# Request for Quotation

RFQ NUMBER  
 PTR07010

LINE	QUANTITY	UOP	CAT. NO.	ITEM NUMBER	UNIT PRICE	AMOUNT
				ADDENDUM NO. 2		
				THIS ADDENDUM IS ISSUED TO ADD AND CLARIFY DRAWINGS, SKETCHES, AND SPECIFICATIONS TO THE ORIGINAL CONSTRUCTION DOCUMENTS AND TO ANSWER QUESTIONS RAISED AT THE MANDATORY PRE-BID MEETING AND THOSE RAISED PRIOR TO THE 12/28/2006 DEADLINE FOR QUESTIONS.		
				ALSO, TO EXTEND THE BID OPENING DATE TO ALLOW TIME FOR VENDORS TO INCORPORATE THIS INFORMATION INTO THEIR BID RESPONSES.		
				BID OPENING DATE IS EXTENDED TO: 01/18/2007 BID OPENING TIME REMAINS: 1:30 PM		
				***** END ADDENDUM NO. 2 *****		
0001	1	EA		968-20		
				CONSTRUCTION/RENOVATION

The following are clarifications from questions and comments from the Fairmont Marion County Transit Authority's mandatory pre bid meeting held on Thursday, December 14, 2006.

DRAWN: LMW	CHECKED: JMB
SCALE: AS INDICATED	
DATE: DECEMBER 21, 2006	
JOB NO. PR42410	
REF. SHEET AD100	
DWG. NO. SKA-1

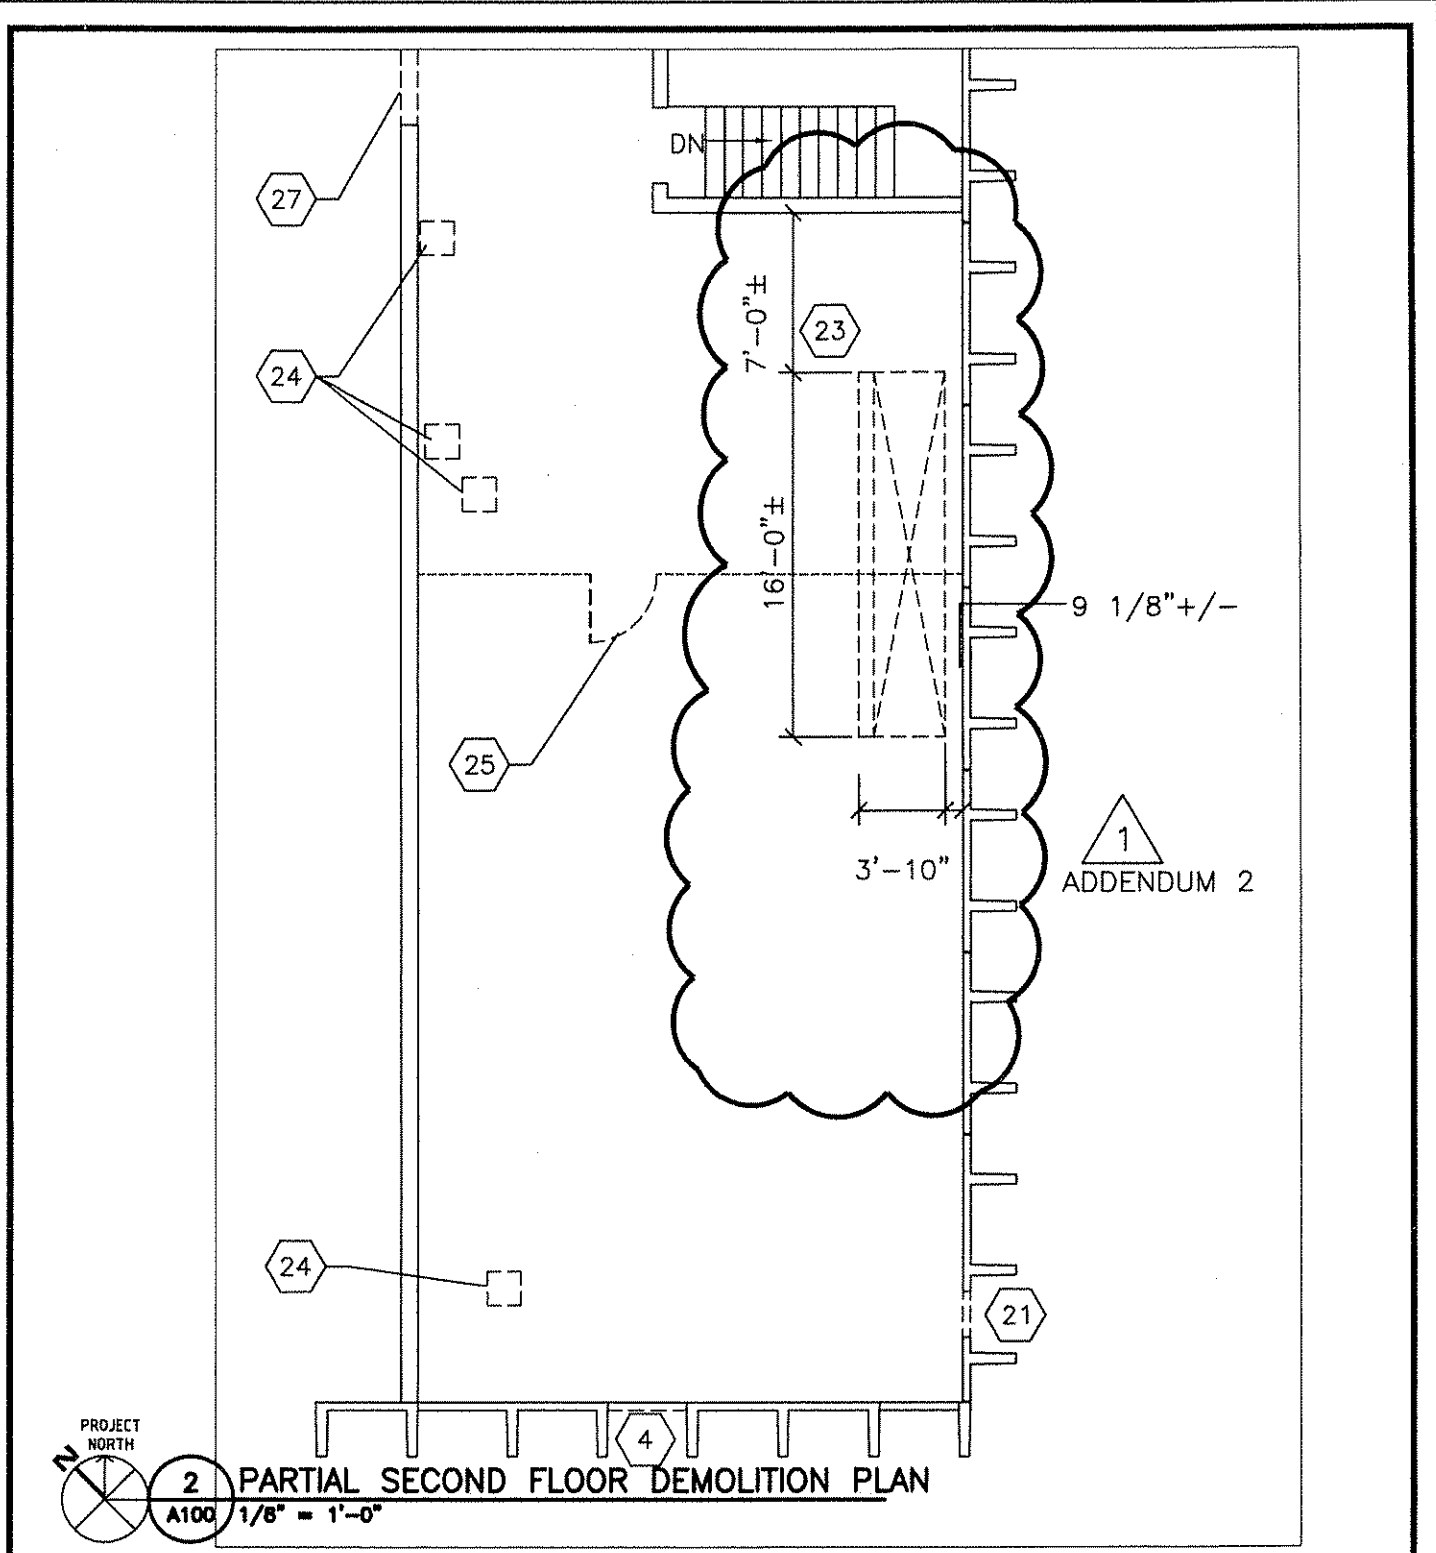
- 3. Sheet AD100. Delete Note 12 and replace with the following, "REMOVE EXISTING WINDOW UNIT.
- 4. Sheet AD100. See Sketches SKA-1and SKA-2 for revisions.

DRAWN: LMW	CHECKED: JW
SCALE: AS INDICATED	
DATE: DECEMBER 21, 2006	
JOB NO. PR42410	
REF. SHEET A404	
DWG. NO. SKA-3

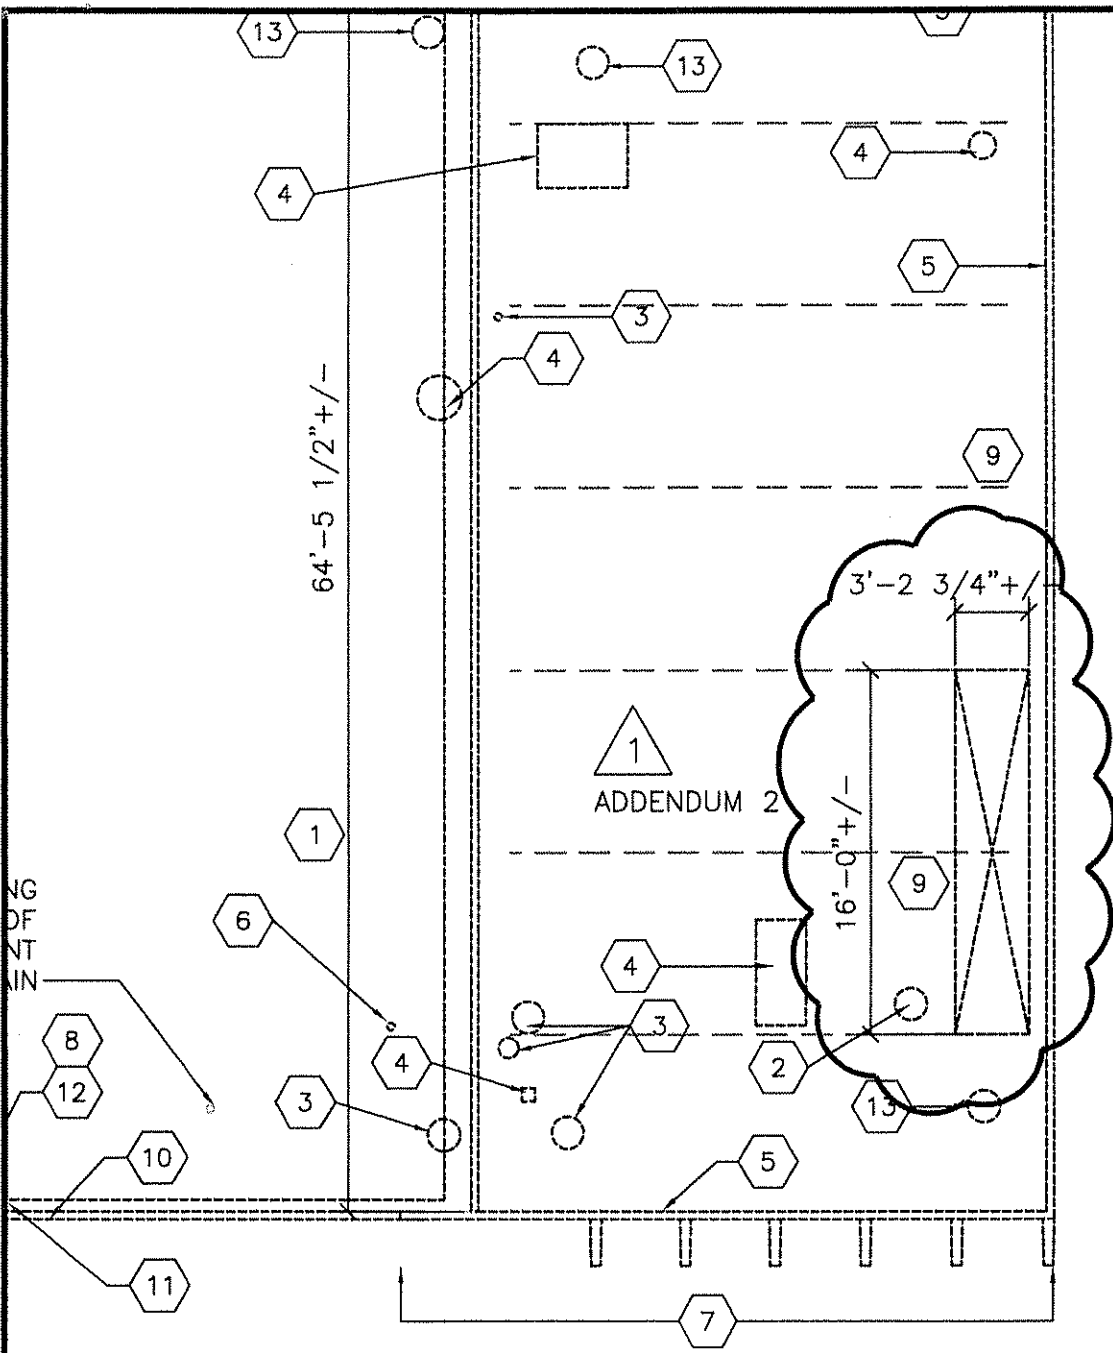
- 23. Sheet A404. See Sketch SKA-3 for revisions.
- 24. Sheet A500. DEMOLITION NOTE 9. Delete the text of note 9 and replace with the following. "REMOVE PORTION OF PRECAST CONCRETE DOUBLE T. COORDINATE SIZE AND LOCATION WITH NEW STAIRS AND STRUCTURAL DRAWINGS."

DRAWN: LMW	CHECKED: JMB
SCALE: AS INDICATED	
DATE: DECEMBER 21, 2006	
JOB NO. PR42410	
REF. SHEET A500	
DWG. NO. SKA-4

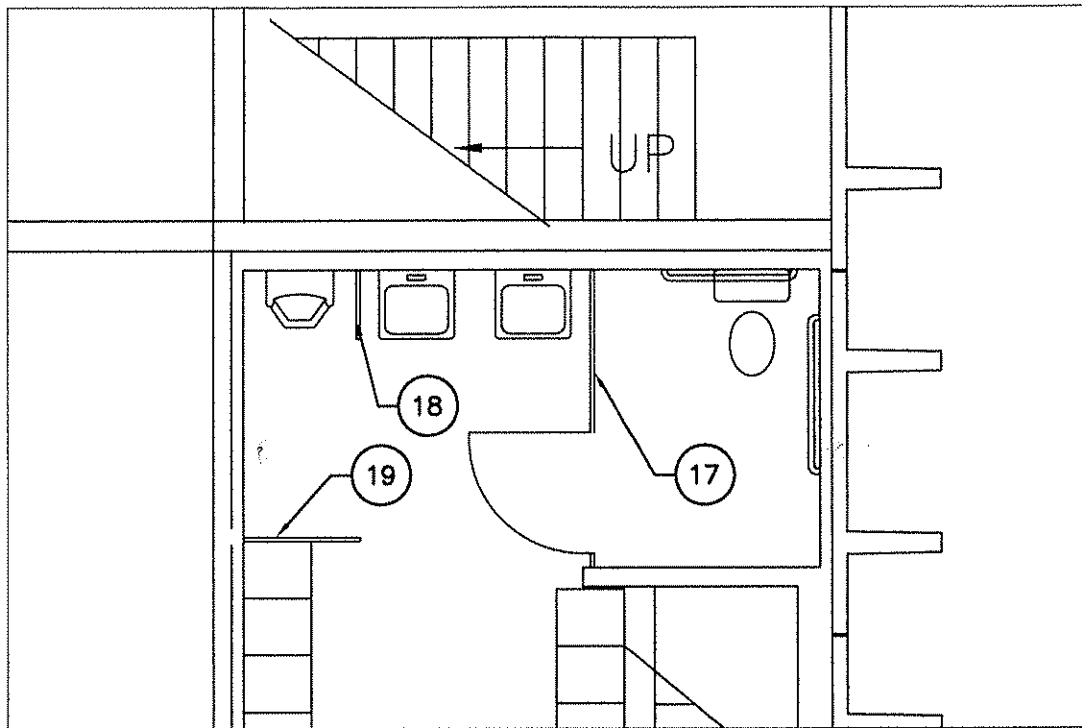
- 25. Sheet A500. NEW WORK NOTE 6. At the end of note 6 add, "EXACT LOCATION OF EXPANSION JOINT SHALL BE COORDINATED IN THE FIELD BY THE ARCHITECT."
- 26. Sheet A500. See sketch SKA-4 for revisions.
- 27. Sheet A501. Detail 3/A501. Omit note beginning with, "CONCRETE LANDING..." and replace with, "SEE STRUCTURAL DETAIL 8/S301."

DRAWN: JMB	CHECKED: RMH
SCALE: AS INDICATED	
DATE: DECEMBER 8, 2006	
JOB NO. PR42410	
REF. SHEET S100	
DWG. NO. SKS-1

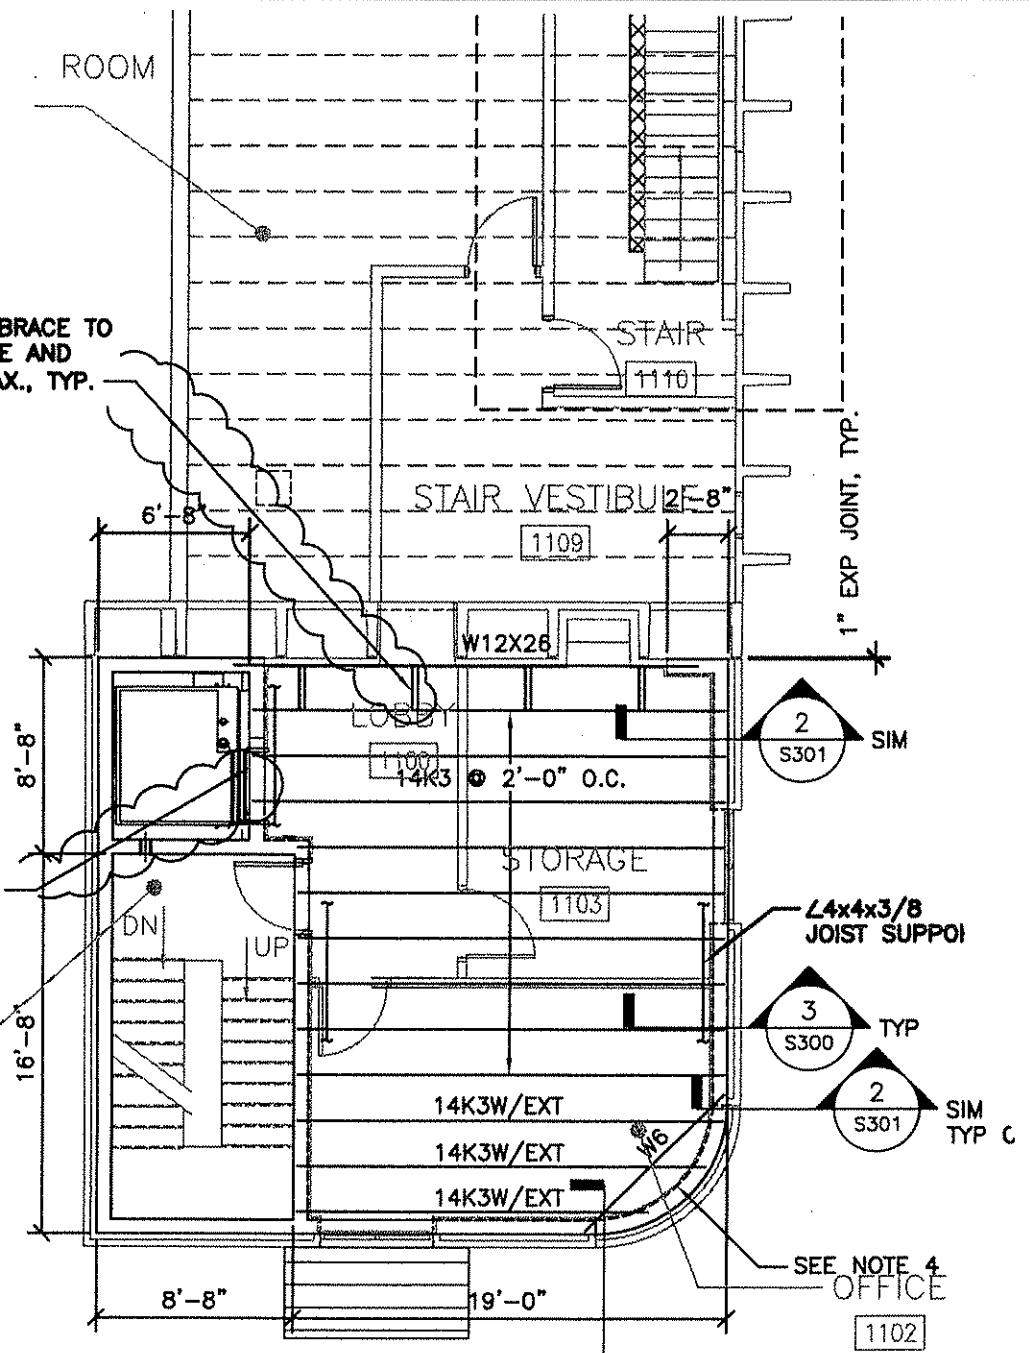
- 1. Sheet S100 **STRUCTURAL GENERAL NOTES:** Cold Form Steel Framing;  
Add Note: Attach Both Flanges of Studs of All Exterior Walls and Interior Walls Marked as 'Shear Walls' to Top and Bottom Runners With Two Screw or Weld.
- 2. Sheet S200 **STRUCTURAL FLOOR AND ROOF PLANS:** Detail 1/S200;  
Delete Note: Segmented Block Planter Wall, See A401.  
Add Note: Concrete/Masonry Planter Wall, See Section 1/A401.
- 3. Sheet S200 **STRUCTURAL FLOOR AND ROOF PLANS:** Detail 1/S200, 6' high – 8' CMU Wall;  
Add Note: See Detail 4/A403.

DRAWN: SCC	CHECKED: RMH
SCALE: AS INDICATED	
DATE: DECEMBER 8, 2006	
JOB NO. PR42410	
REF. SHEET S300	
DWG. NO. SKS-5

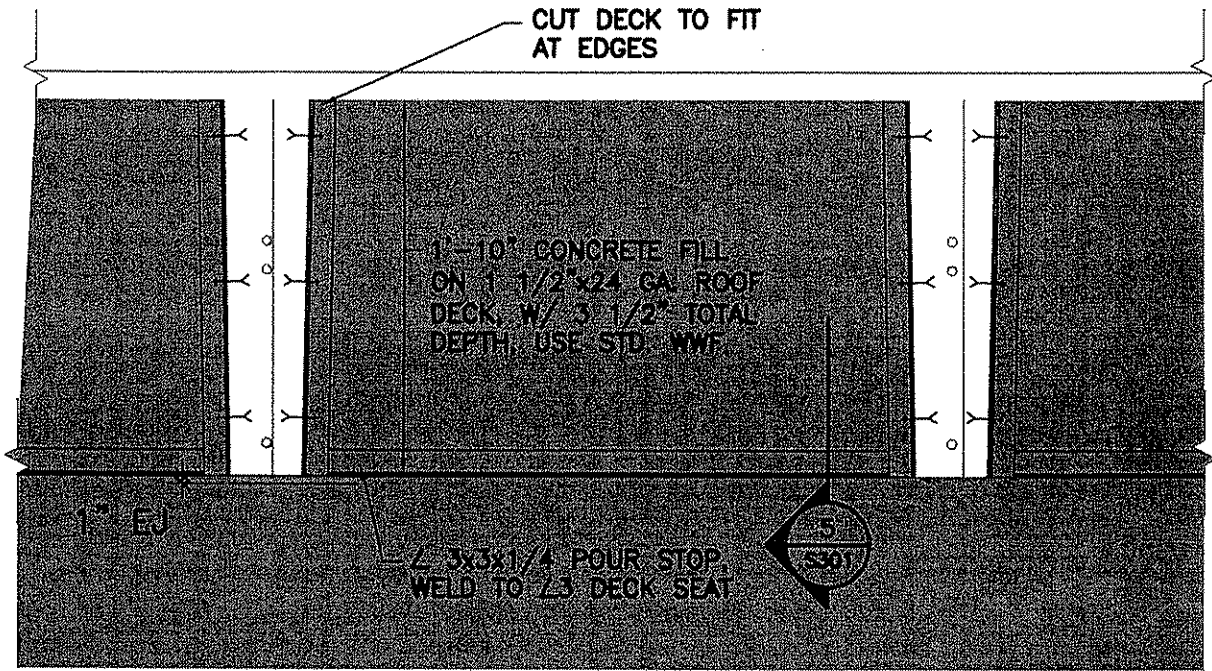
7. Sheet S300 **STRUCTURAL DETAILS AND SECTIONS:** Detail 11/S300;  
Add Note: Detail is Typical for all 3<sup>rd</sup> Floor Exterior Wall Over Existing Roof.

DRAWN: SCC	CHECKED: RMH
SCALE: AS INDICATED	
DATE: DECEMBER 8, 2006	
JOB NO. PR42410	
REF. SHEET S301	
DWG. NO. SKS-8

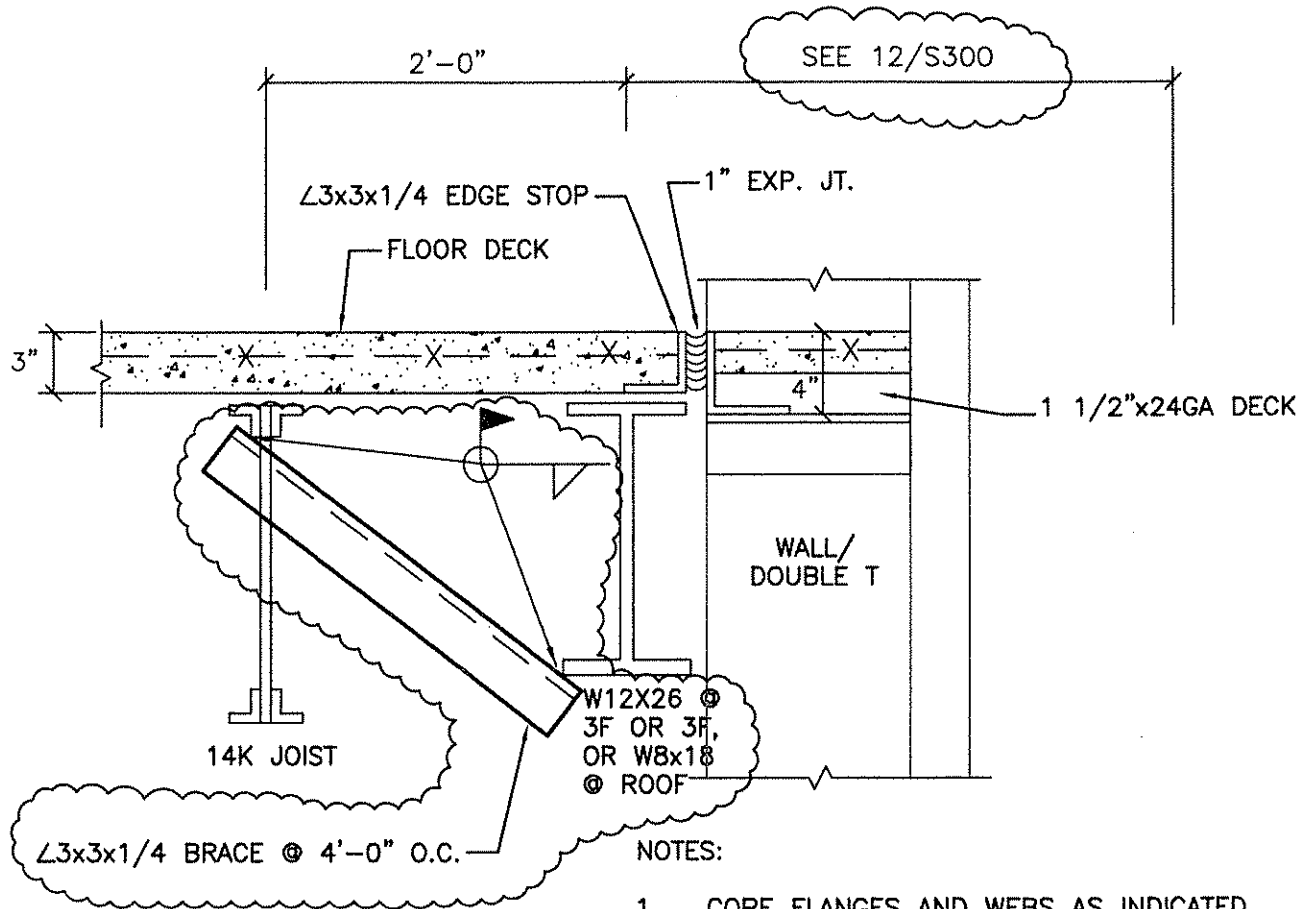
8. Sheet S301 **STRUCTURAL DETAILS AND SECTIONS:** Detail 8/S301;  
Delete Note: 2" Key @ Sidewalk.
9. Sheet S301 **STRUCTURAL DETAILS AND SECTIONS:** Detail 7/S301;  
Add Note: Coordinate Location of Elevation Sump with Elevator Manufacturer.

DRAWN: SCC	CHECKED: RMH
SCALE: AS INDICATED	
DATE: DECEMBER 8, 2006	
JOB NO. PR42410	
REF. SHEET S400	
DWG. NO. SKS-10

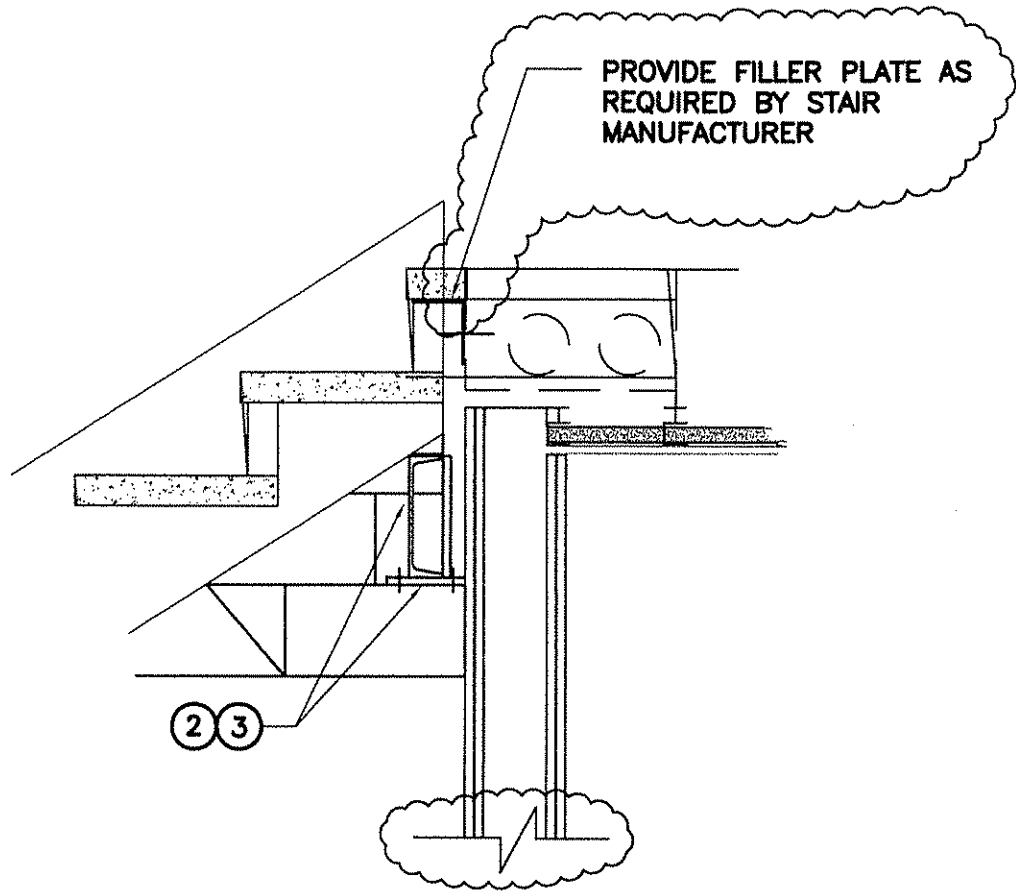
10. Sheet S400 **STAIR 114 PLAN AND SECTION:** Detail 2/S400;  
Delete Note: Sawcut 8" Floor Plank, 4'-1½" x 16'-0" for Stair Access.  
Add Note: Sawcut 8" Floor Plank, 16'± for Stair Access. See Architectural Drawings.
